Re: **Perjury Statement-**
Revised Sub-Slab Attenuation Factor Determination Work Plan
Searway Property (SLIC Case No. RO0002584)
649 Pacific Avenue
Alameda, California

Re: *Revised Sub-Slab Attenuation Factor Determination Work Plan*
Searway Property
649 Pacific Avenue
Alameda, California

**ALAMEDA COUNTY HEALTH CARE
SERVICES AGENCY LETTER
DATED FEBRUARY 18, 2010**

Subject: SLIC Case No. RO0002584 and Geotracker Global ID SL0600150413, Searway Property, 649 Pacific Avenue, Alameda, CA 94501 – Technical Comments on Work Plan

SITE LAYOUT AND PROPOSED SAMPLING LOCATIONS

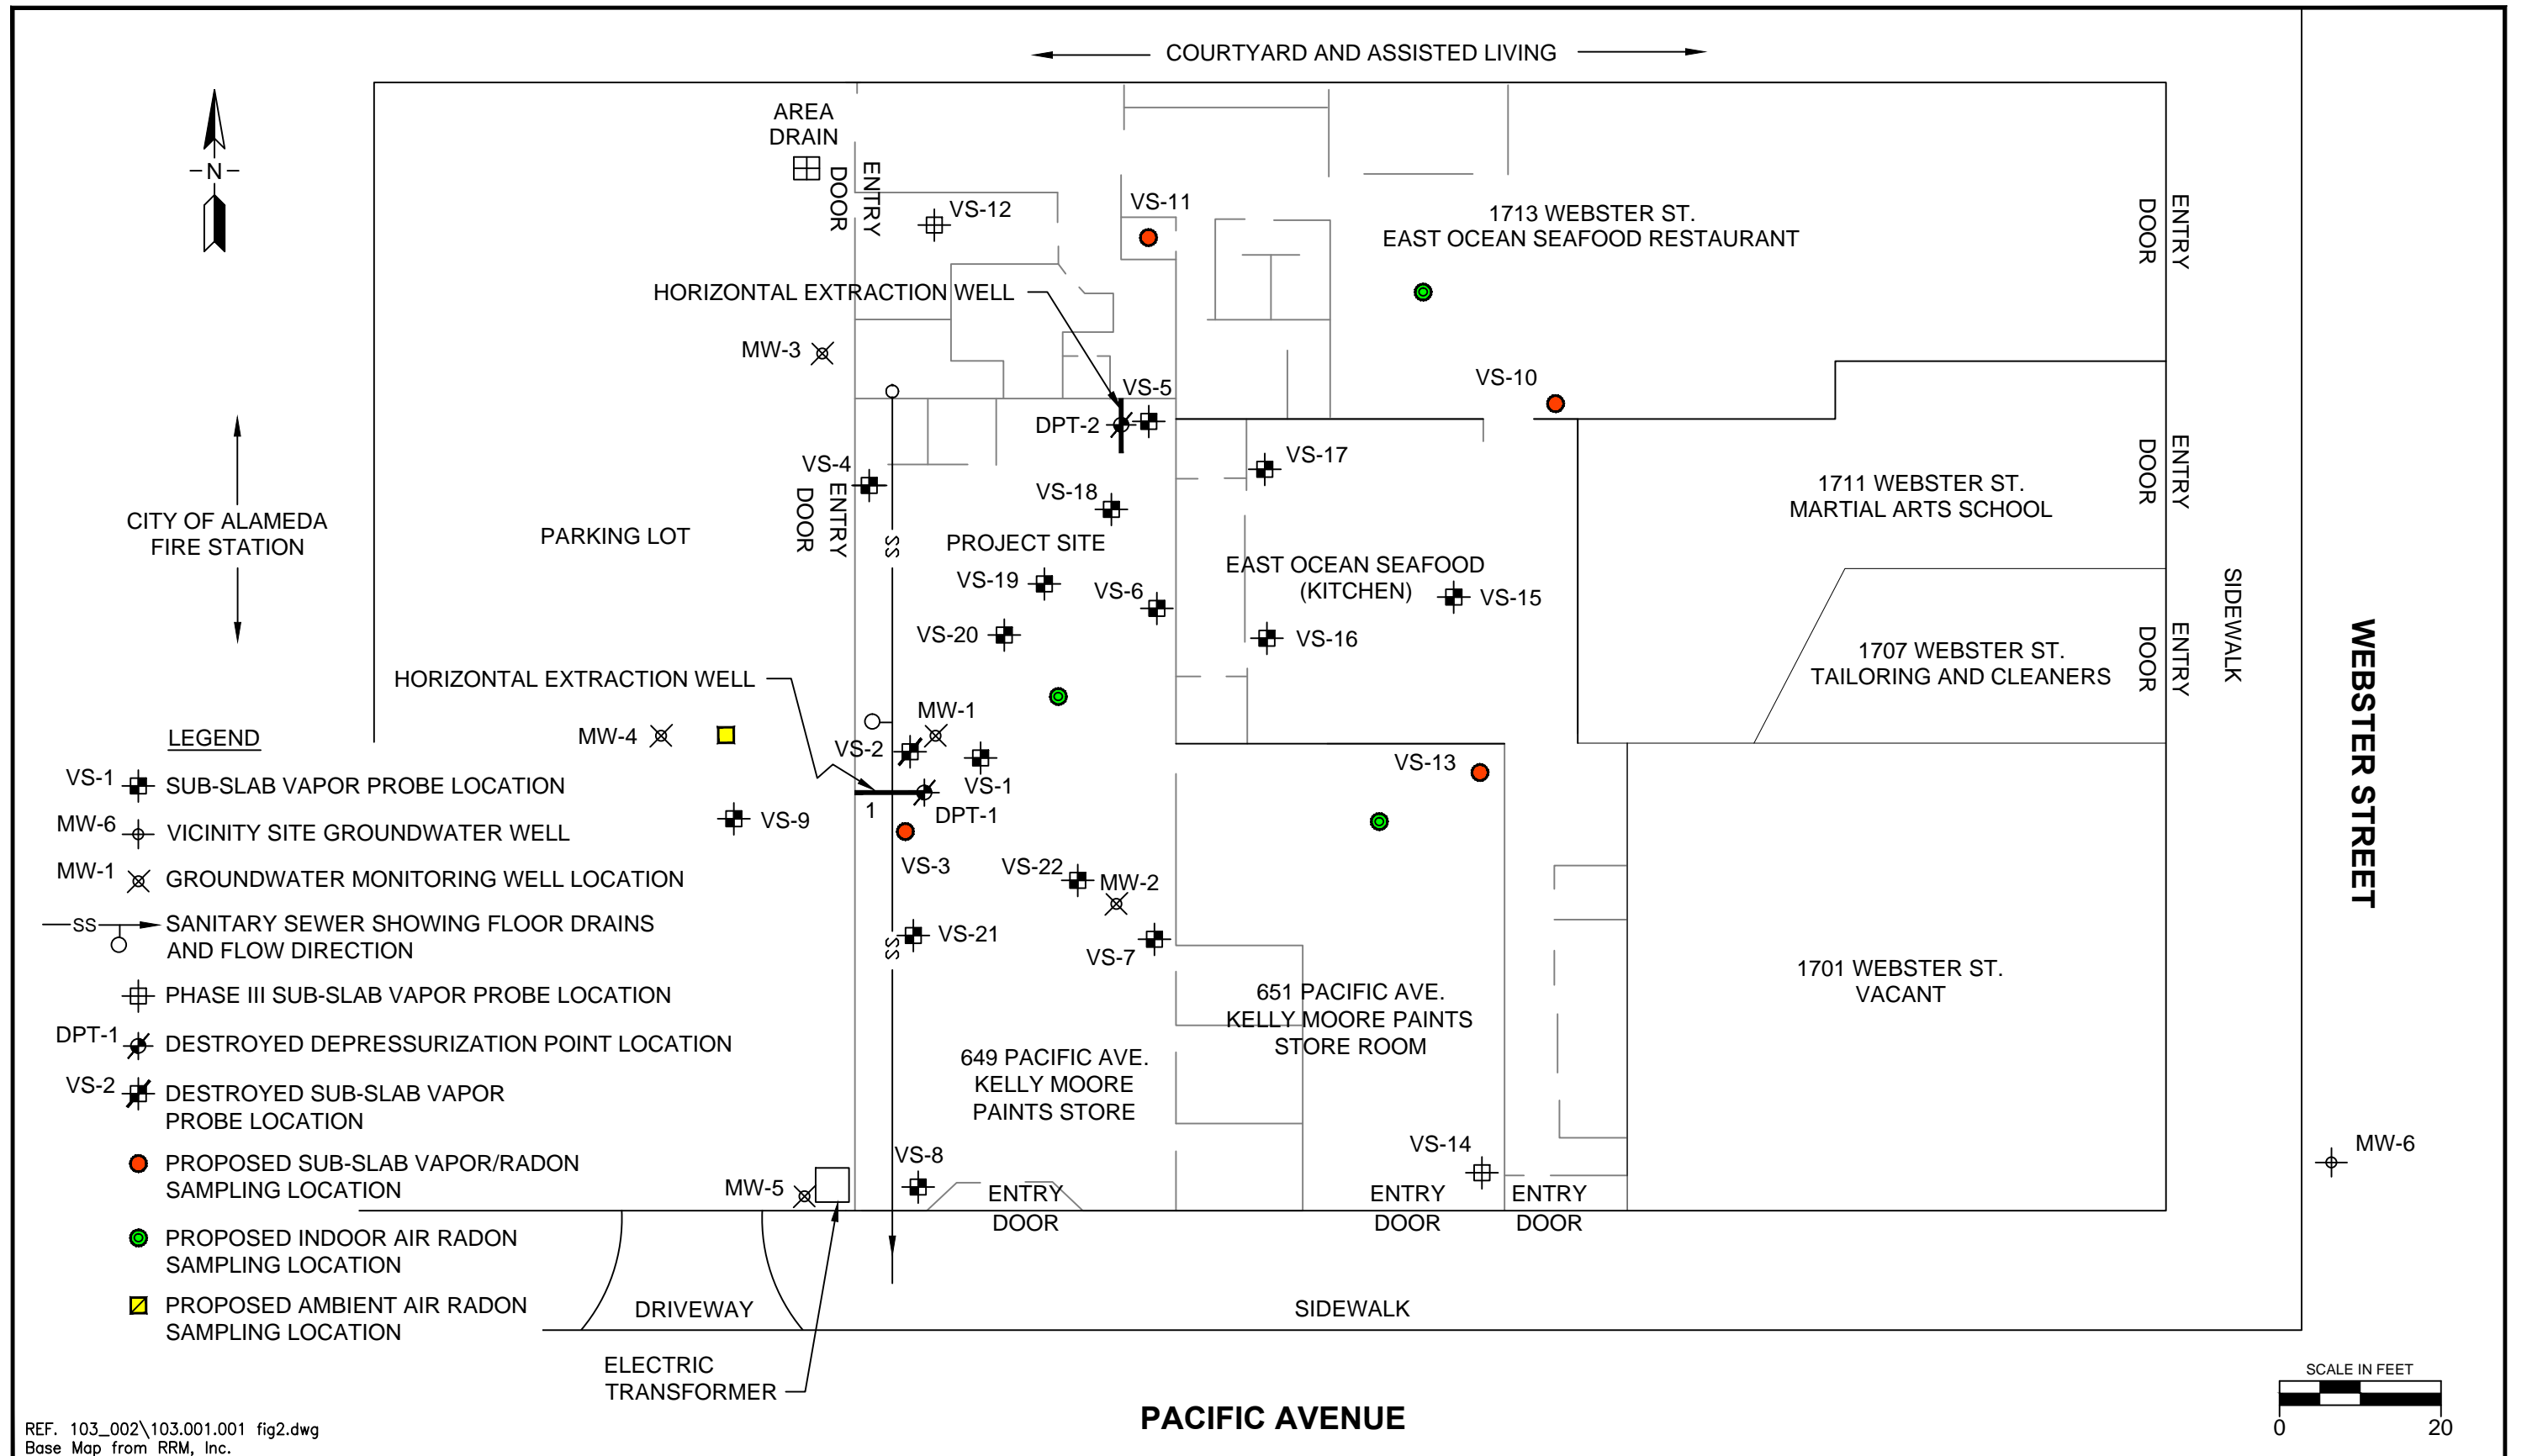
1. **Scope of Proposed Sub-slab and Indoor Air Sampling.** The Work Plan proposes the collection of soil vapor samples from three sub-slab vapor probes, one indoor air sampling location, and one outdoor ambient air sample. All three sub-slab vapor samples (VS-5, VS-19, and VS-3) are located within the Kelly Moore Paints store. VOCs have also been detected in sub-slab vapor samples at locations within the adjacent East Ocean Seafood Restaurant, which appears to be located within a different building than the Kelly Moore Paints store. The different buildings may have different floor slabs, ventilation, floor coverings, and other conditions that may affect vapor attenuation. We also note that potential vapor entry points in the foundation of the Kelly-Moore Paints store were inspected and sealed as part of the diagnostic test procedures conducted on October 17, 2007 but foundation penetrations in the East Ocean Seafood Restaurant were not sealed with the exception of the northwestern corner of the East Ocean Seafood Restaurant,. Due to these differences, the estimation of an attenuation factor based solely on results from the Kelly-Moore Paints store may not be representative of conditions in the East Ocean Seafood Restaurant. Therefore, we request that you add a minimum of one sub-slab vapor sample and one indoor air sample within the East Ocean

Seafood Restaurant. Based on previous results, the highest concentrations of VOCs beneath the sub-slab of the East Ocean Seafood Restaurant are present in the area of VS-11. Please include plans to collect a minimum of one additional sub-slab vapor sample from VS-11 and one additional indoor air sample from the area near VS-11.

- Trinity will notify the site tenants (Kelly Moore Paints and East Ocean Seafood Restaurant) at least 48 hours before sampling.
- Seven days after SSVD shutdown, four sub-slab vapor points (VS-3, VS-10, VS-11 and VS-13) will be sampled for radon. Probe VS-11 was added at the request of ACHCSA. These locations were selected to sample various areas within the building, both inside and outside the existing VOC plume. Proposed sampling locations are shown on Figure 2.

1713 Webster Street, and in the Kelly Moore Paint storage facility at 651 Pacific Avenue. These sample locations were selected to sample various rooms inside the building, while staying out of closets, walkways, and pathways of air current blowing between doorways. These three indoor air samples will provide a larger data set for determination of the AF in lieu of time-weighted sampling which is not practical for sub-slab samples as described below. Proposed sampling locations are shown on Figure 2.

As requested by ACHCSA Comment #1, an indoor air sample for radon analysis will be collected from a location near VS-11. However, the USEPA guidance⁵ recommends against indoor-air radon sampling in closets, bathrooms and kitchens, so the indoor air sample near VS-11 will be located in the East Ocean Seafood Restaurant dining room, generally between sub-slab Probes VS-11 and VS-10. This location will also be subject to the pre-sampling inspection and closed-building conditions described in the referenced guidance and discussed below under Sampling Procedures.
